Benchmark Retail Cost Index for Electricity: 2011-12 – Draft Decision

AGL submission to the Queensland Competition Authority
Date: 11 February 2011

Figure 1 – ORER commissioned modelling of STC creation

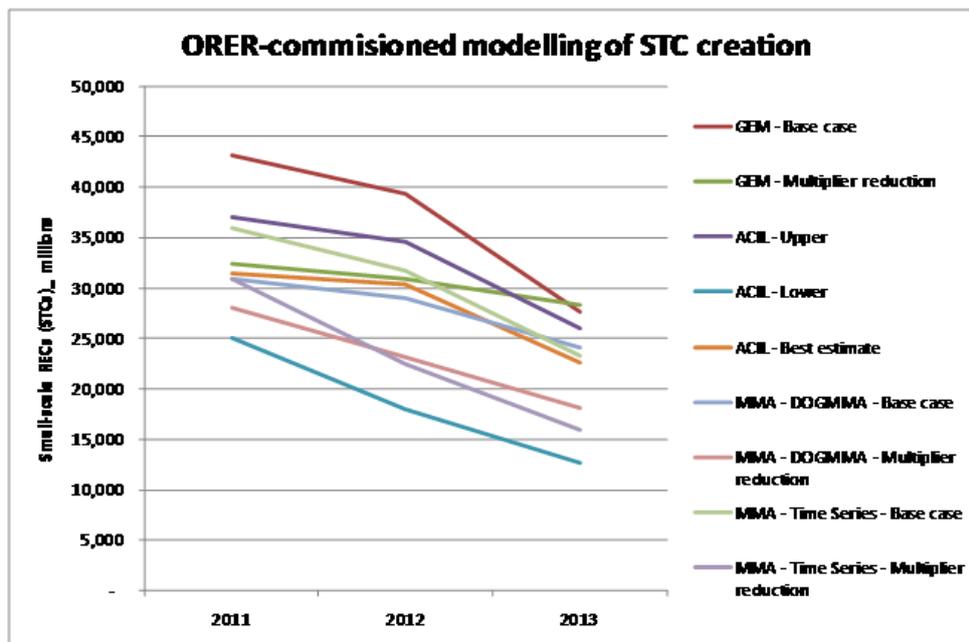
AGL also notes in this respect that the *ACIL-Low scenario* is predicated on a range of changes to state-based complimentary policies. For example, the *ACIL-Low scenario* assumes that Queensland and Western Australia will close their feed-in tariff schemes at some point during the projection period. AGL is of the view that this is an overly conservative assumption, and renders the *ACIL-Low scenario* inappropriate for use in the BRCI forecast. Current policy settings should be used as the premise of any forecast, unless there is a high probability that the policy settings will change. AGL does not understand this to be the case, and would seek clarification from ACIL if they believe there is a probability of change.

In establishing the 2011 STP, ORER assumed that 28 million STCs would be created during the year. As can be seen in Figure 1 this estimate is closest to the 'MMA – DOGMMA – Multiplier reduction' scenario i.e. 28,079,000 STCs in 2011.

AGL notes that the *ACIL - Low scenario* results in the lowest STC amount of all scenarios modelled, and the 2011 STC creation in the *ACIL-Low scenario* is significantly lower than the STC amount adopted by ORER. ACIL state that there is "significant uncertainty regarding the number of STCs created over this period (as highlighted by the size of the range) due to potential changes in rebates and feed-in tariffs over the period"¹⁰, however AGL note that no explanation is provided as to why the assumptions used for 2012 have apparently changed so significantly from 2011.

AGL suggest that using a 2012 STC volume in line with the 'MMA – DOGMMA – Multiplier reduction' scenario would more closely reflect the assumptions adopted by ORER in

Figure 2 – Cal11 & Cal12 AFMA GEC Prices

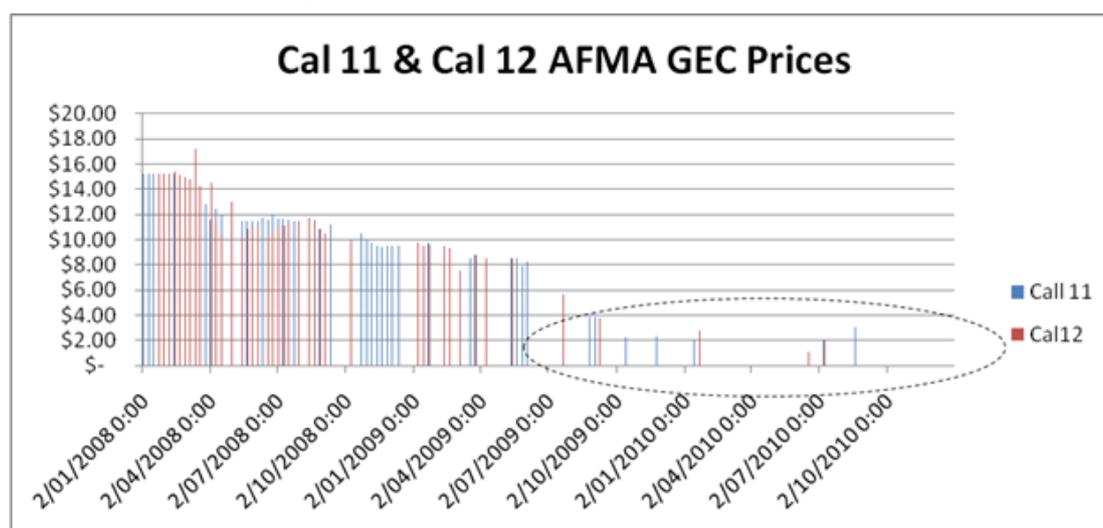
- AFMA have only published 11 data points for Cal 11 from 1 July 2009 through to 31 December 2010. This means that in only 11 weeks of the 18 months, were AFMA able to solicit quotes from market participants; and
- AFMA have only published 5 data points for Cal 12 in that same 18 month period.

The number of data points provided by AFMA during the relevant time period is not such as to provide a representative sample of market activity over the period, and any analysis based on this amount of data cannot be considered sufficiently robust to support a change in methodology.
